## Release Notes MobiMed Smart v4.2.14

Software Article Number 490210871 (Software Build No 4.2.14.0\_16.05.23.1)

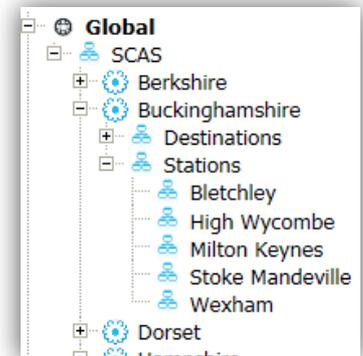
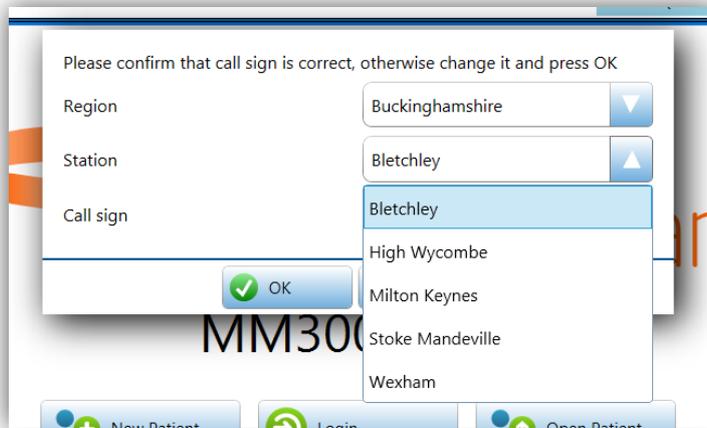
- Increase low battery/warning level setting to 25% in order to better maintain batteries and give an earlier warning of depletion.
- Region and station selection is now done via drop down controls with pre-set lists based on the AdminTool grouping. In previous versions these were free text fields that allowed for any kind of input and typos. (Originally implemented in 4.2.11 according to item 5836, but enabled in 4.2.14 after addressing 5825, 6387, and 6548 as per below).

The below is an example of the new ePR UI for SCASFT with the corresponding grouping in AdminTool to the right:

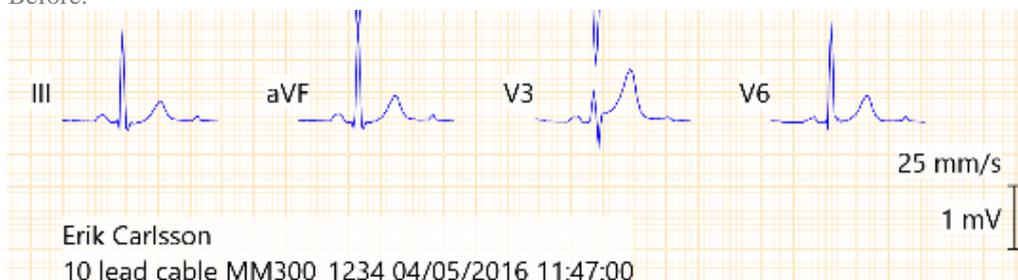
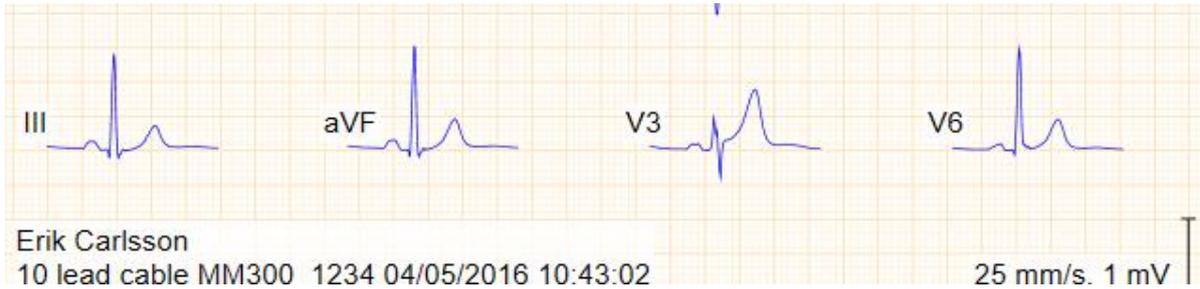
- Allow KeepIP to connect from PCs with Hyper-V (6560)
- Allow PU reboot during update process (6517)
- Increase quality and lower storage requirements of ECG complexes and waveforms in ePR. Draw based on samples (instead of bitmap snapshot) (5782)

Before:

After:
